Answers to Questions from Bidders

Issued: Friday, July 11, 2025

ASMSA FB-25-006 IFB: Maintenance Building & Wood Shop Construction Project

ASMSA - MAINT. BUILDING & WOOD SHOP
PARTIAL OF SHT C.4
N.T.S. APPENDUM #5, ITEM #5

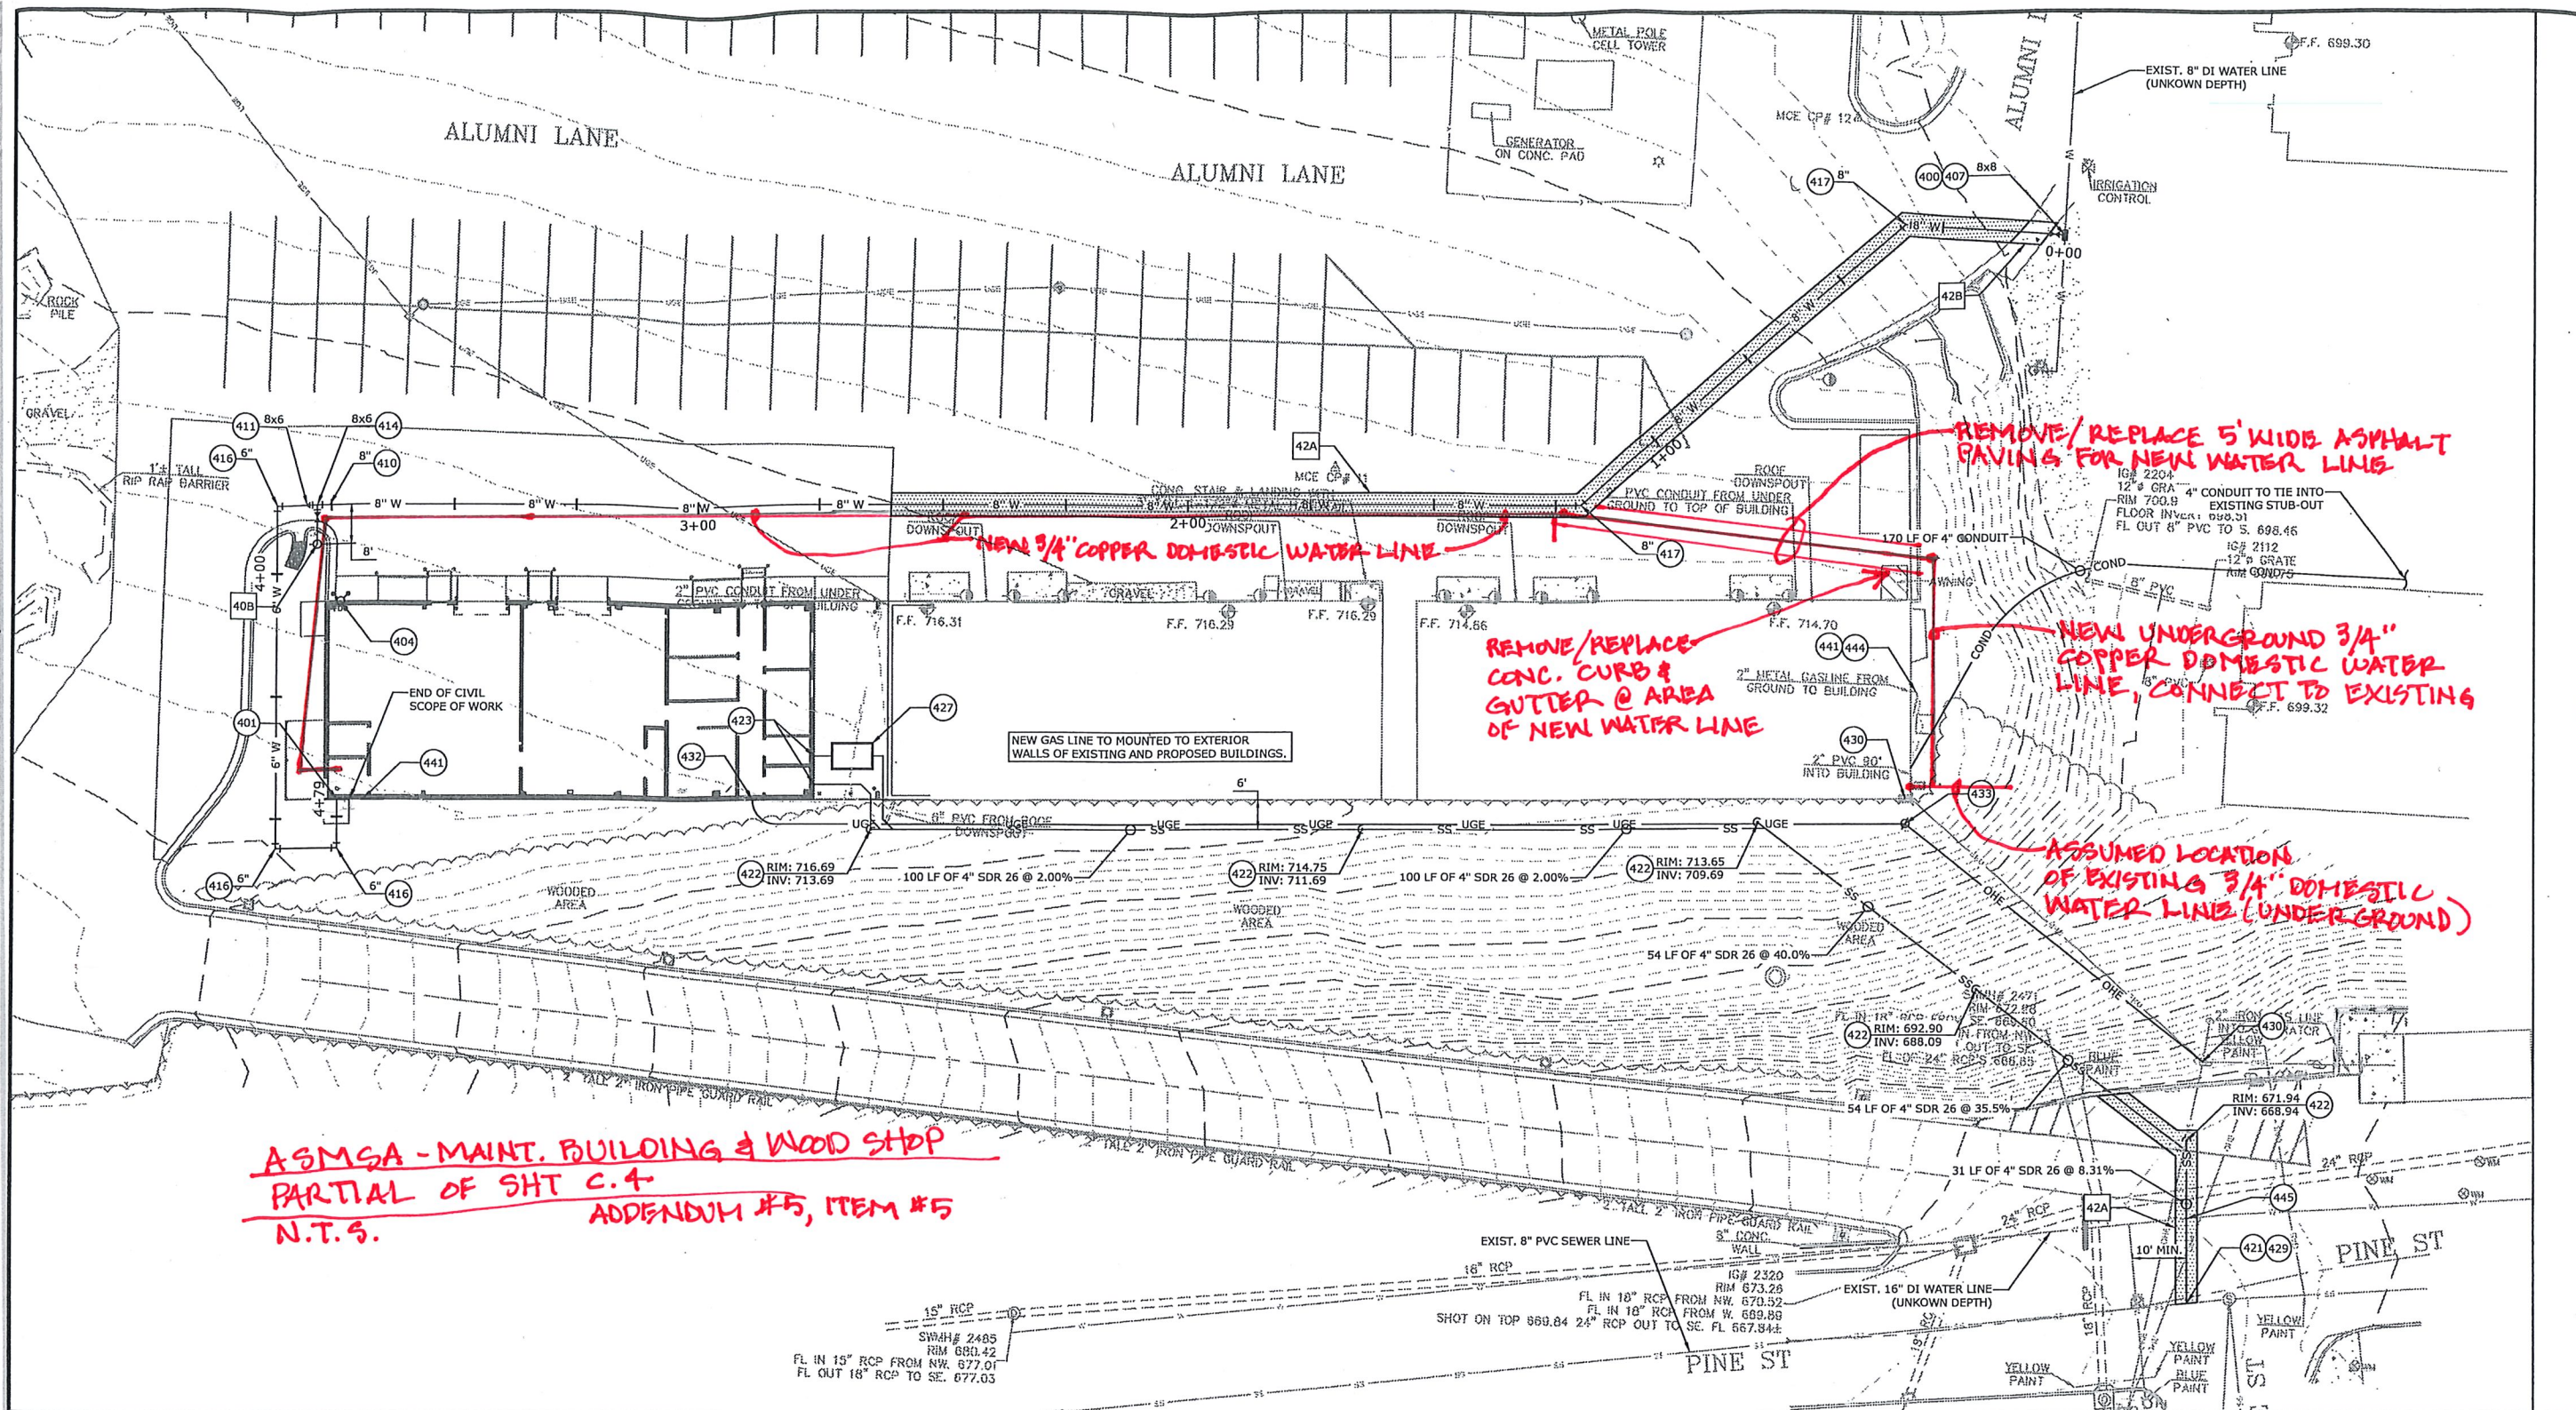
A. Where is the location of the domestic water tie in?

O. On Sheet P2.1 Detail 1, the 3/4" plumbing line appears to be missing continuation details.

Where is

this line routed?

1. **Response:** See attached drawing.

1. **Response:** Reference "Question A" under Item No. 5 of this Addendum and see attached drawing.
